Letter - S2: Document Id - TOPOCK-MWD 00001 Page 64

DOCUMENT REVIEW AND COMMENT RESOLUTION SHEET

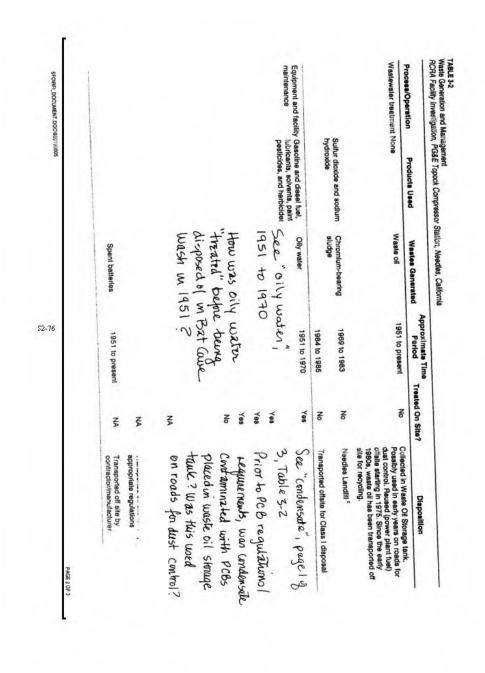
Figure 3-1 . Iduntify the "Former Chemical Stronge Define in the text what is included in mentioned in Instinical the team" piping" that is used on this Figure. Identify areas where sandblasting activities have occurred in the past and currently Identify location of " 1000 gallon pipeline liquids storage tank" mentioned in historical documents I dentify all "dischange pipe I deutify storm water pipes/culvents terminators", both current and I downify newly identified landfill Edenlify where sand blactury wastes have been duoposed. historical. I dentify the current and historical locations of the natural gas pipelines Using different colors (brighter) for current NS. historical priping would be helpful . Identify locations of any drywells or cisterns Identify all floor drains and associated conveyances, both current and historical FIGURE 3-1 **FACILITY LAYOUT** RCRA FACILITY INVESTIGATION (RFI)

DTSC RESPONSE: PG&E shall add additional available information to Figure 3-1 as available. PG&E has already performed a significant historical information search and have compiled sufficient chemical usage and waste disposal information to support the identification of potentially affected areas and contaminants of concern, and the development of conceptual site models. However, PG&E shall make a reasonable attempt to obtain the additional requested information. See also the response to Comment S2-1.

PG&E RESPONSE: No changes have been made to Figure 3-1. The only known information regarding sandblasting activities is at the Sandblast Shelter. No information is available regarding sandblast waste disposal. The Pipeline Liquids Tank can not be called out in Figure 3-1 because it is located along the northeast edge of the site (significantly east of the area covered by this figure). The tank has been called out in Figure 4-1.

PG&E is unable to identify discharge pipe terminators because the information is not available. A schematic of the wastewater treatment system piping is provided in Figure 4-2. No cisterns or dry wells were identified. As discussed earlier, floor drains have not been added to this figure because they are generally known to discharge to the oily water treatment system. The former chemical storage sheds are located within AOCs 5, 6, and 19 (see Figure 4-1). All sumps are shown on Figure 3-1, impoundments at the site are limited to the Old Evaporation Ponds (SWMU 10), and the new Class II Evaporation Ponds (both sets of ponds are outside of the area covered by this figure). SWMU 10 is shown in Figure 4-1. We are not familiar with any newly-identified landfill.
